**RE: 6105 Copper Rose St. NE**  
**Engineer's Certification Date: 08/08/23**  
**Engineer's Stamp Date: 04/06/23**  
**Hydrology File: E23D003O1**

Based upon the information provided in your submittal received 08/10/2023, the Grading and Drainage Plan is approved for Building Permit and Building Pad Certification for 6105 Copper Rose St. NE. Please attach a copy of this approved plan in the construction sets for Building Permit processing along with a copy of this letter.

|                                                                         |                                                          | SHEET #<br>C1                     |

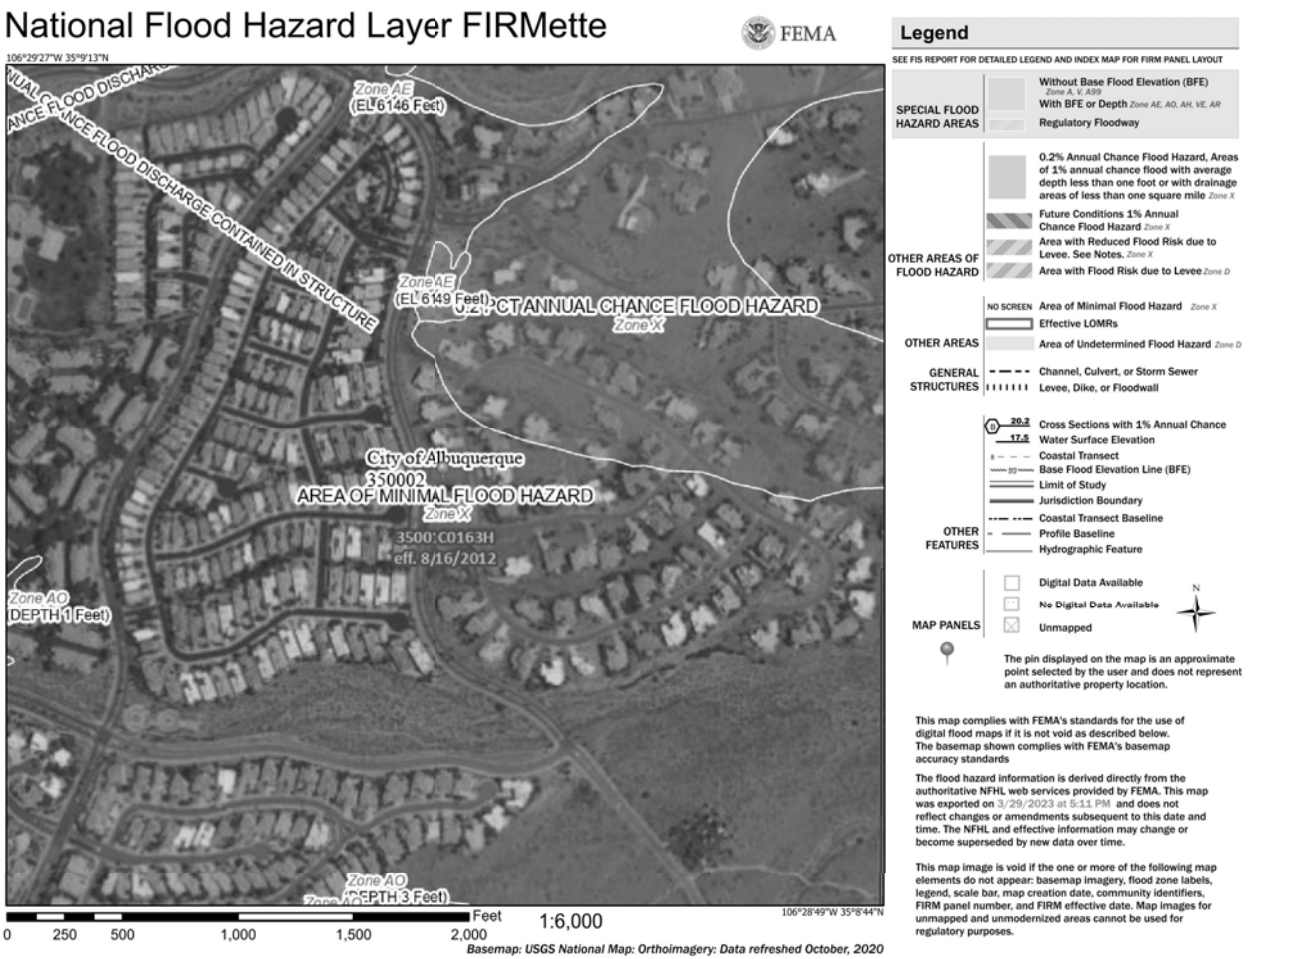
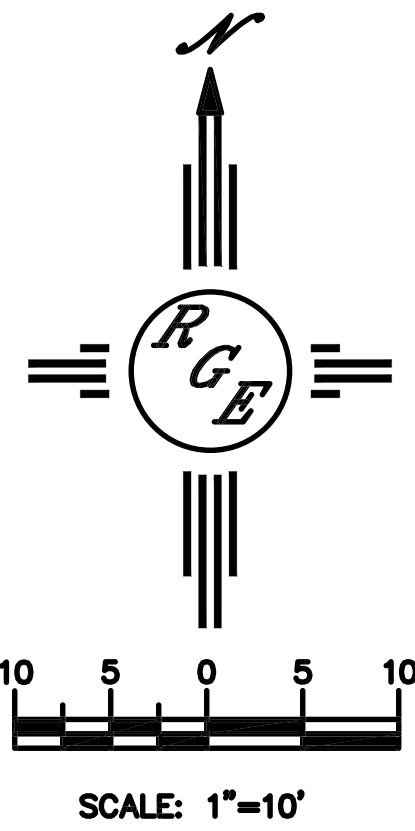
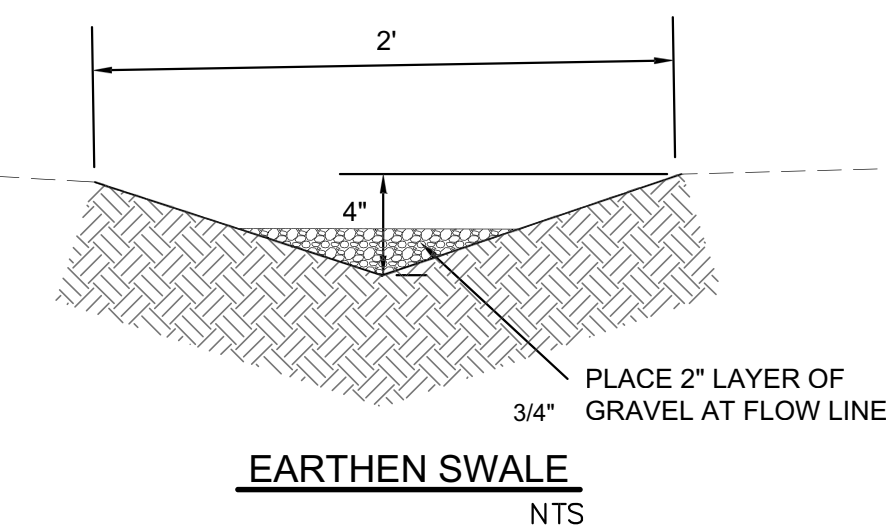
1. Engineer's Certification, per the DPM Part 6-14 (G): Engineer's Certification Checklist for Subdivision and Part 6-14 (H): Required Certification Language is required.
